Memo

Re: Consultation on an Application

Planning Application Ref: PL/25/1263

Address: 146 Southampton Street, Reading, RG1 2RD

Approximate location of one of the piers

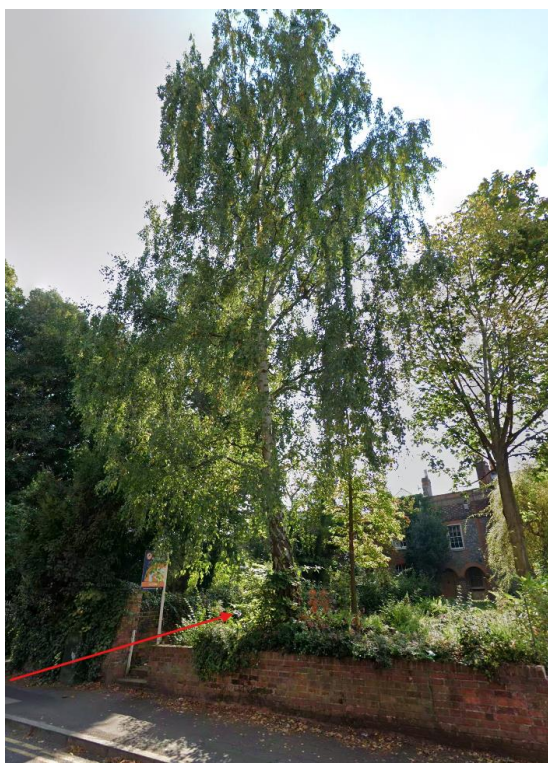
Some clarity needs to be provided on the installation of the brick piers as they are extremely close to the base of T1 and I am unclear on the methodology proposed. The AIA states '*The installation of the brick piers, kerb edge and new driveway will need to be carried out by hand and following the methods outlined in the Arboricultural Method Statement to ensure trees are not damaged during the construction works.*', and then later states '*new brick tiers shall be laid on top of a no-dig load-bearing sub-base comprising a geotextile membrane, overlaid with a 3D cellular confinement system (e.g., CellWeb TRP) filled with clean angular Type 3 aggregate*'. Cellular confinement systems are used for surfacing to accommodate for future root growth are flexible to allow for root movement. I am unclear whether brick piers can be installed this way – there isn't an example of this in Appendix 4 like there is for the kerb edge and surfacing. It is assumed some foundations and thereby excavation will be required to support the stability of the piers. Clarity should be sought whether any excavation is required. Being so close to the base of the T1, if excavation is required, significant roots are likely to be found. If significant roots require severance, this can have a negative impact on tree health so a trial dig would be appropriate to determine whether the piers can be feasibly built whilst minimising any impact on tree health.

The brick piers are so close to T1, which is an early-mature tree that is expected to keep growing, that I question whether there is sufficient space to accommodate for future stem growth. The tree also leans towards the road, over the existing wall and proposed piers, and it is unclear whether there is enough space to install the piers here. The height and dimensions of the piers aren't demonstrated on any of the elevations/plans or mentioned within the AIA. There are concerns that there will be an increased pressure to fell the tree (which I am aware is the applicant's preference currently) as future conflict between the tree and structures is possible. This element needs to be considered with care as I am not currently satisfied on the feasibility of installing brick piers so close to the base and main stem of T1, whilst minimising any impact to tree health and accommodating for future tree growth.

The feasibility of installing brick piers so close to T1 needs to be further demonstrated. Whilst no dig methods have been suggested, I assume the brick piers will need foundations for support, so clarity needs to be sought on this. No dig methods for surfacing have been suggested, but I am not sure if this is appropriate for the installation of brick piers. None of the documents provided by the author of the AIA provide details of how cellular confinement systems can be used for the base of structures. I am also unclear whether future tree growth has been considered to avoid future conflict with the brick piers, as this will increase the pressure to fell the tree. Tree roots can also cause damage to structures and placing new structures so close to the base and well within an RPA of a tree is not ideal, hence this needs to be demonstrated further to ensure the piers can be feasibly built whilst minimising any impact to tree health and taking into account future growth. The final height and dimensions of the brick piers aren't shown in the elevations, so it is difficult to appreciate their final juxtaposition in relation to T1.
